**DRAFT PROPOSED CODE CHANGES
FOR
THE CALIFORNIA BUILDING CODE
CALIFORNIA CODE OF REGULATIONS, TITLE 24, PART 2**

**2016 CALIFORNIA BUILDING CODE
TRIENNIAL CODE CYCLE**

**CHAPTER 11B
ACCESSIBILITY TO PUBLIC BUILDINGS,
PUBLIC ACCOMMODATIONS, COMMERCIAL BUILDINGS AND PUBLICLY FUNDED HOUSING**

FIGURE 11B-703.7.2.6.4
EDGES AND VERTICES ON GEOMETRIC SYMBOLS

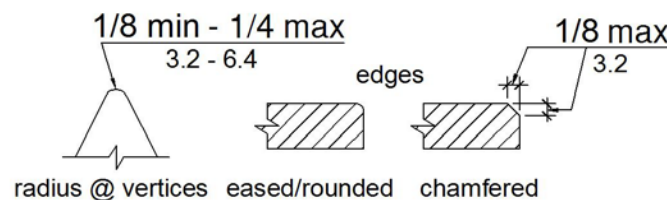
11B-703.7.2.6.4 Edges and vertices on geometric symbols. Edges shall be eased or rounded at 1/16 inch (1.59 mm) minimum, or chamfered at 1/8 inch (3.2 mm) maximum. Vertices shall be radiused between 1/8 inch (3.2 mm) minimum and 1/4 inch (6.4 mm) maximum.

REASON: DSA-AC is proposing to amend these existing sections and add a new section to clarify the technical requirements for geometric symbols located at the entrances to toilet and bathing facilities. DSA is proposing to add dimensional specificity to Sections 11B-703.7.2.6.1, 11B-703.7.2.6.2 and 11B-703.7.2.6.3 to provide greater consistency in the manufacture of the symbols. New Section 11B-703.7.2.6.4 will provide dimensions for eased, rounded or chamfered

edges on all symbols and dimensions for the radius at vertices on triangles. The addition of a figure illustrating the requirements of Section 11B-703.7.2.6.4 will provide clarity and consistency for code users.

FIGURE 11B-812.9
SURFACE MARKING

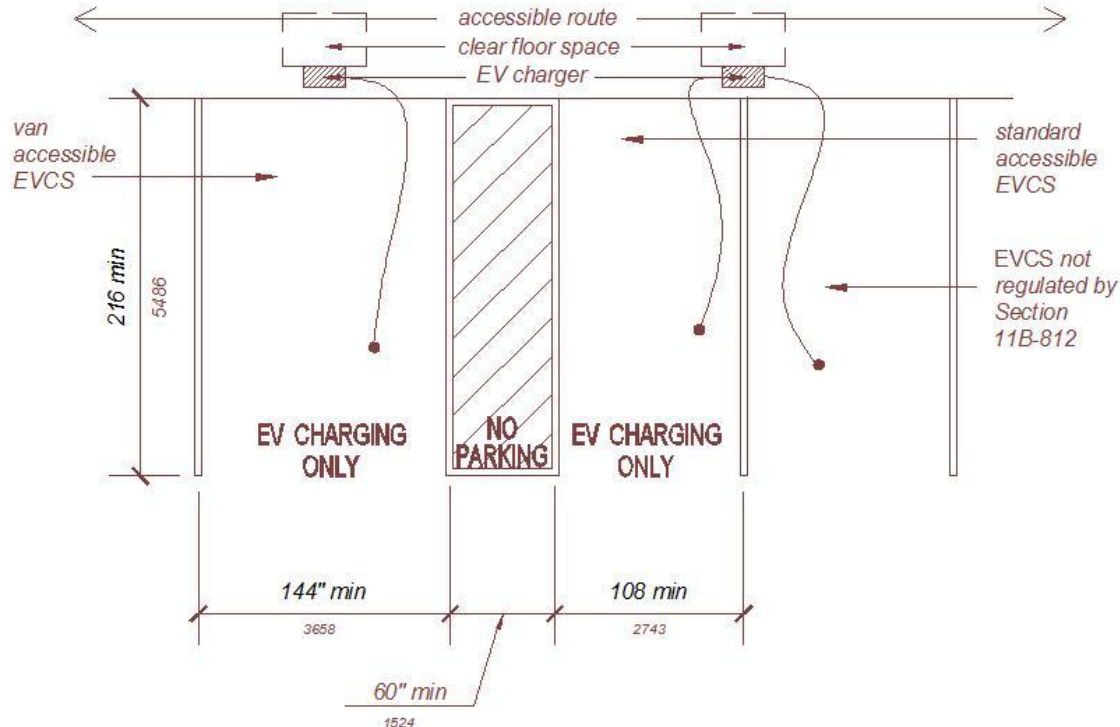
11B-812.9 Surface marking. *EVCS vehicle spaces shall provide surface marking stating “EV CHARGING ONLY” in letters 12 inches (305 mm) high minimum. The centerline of the text shall be a maximum of 6 inches (152 mm) from the centerline of the vehicle space and its lower corner at, or lower side aligned with, the end of the parking space length.*
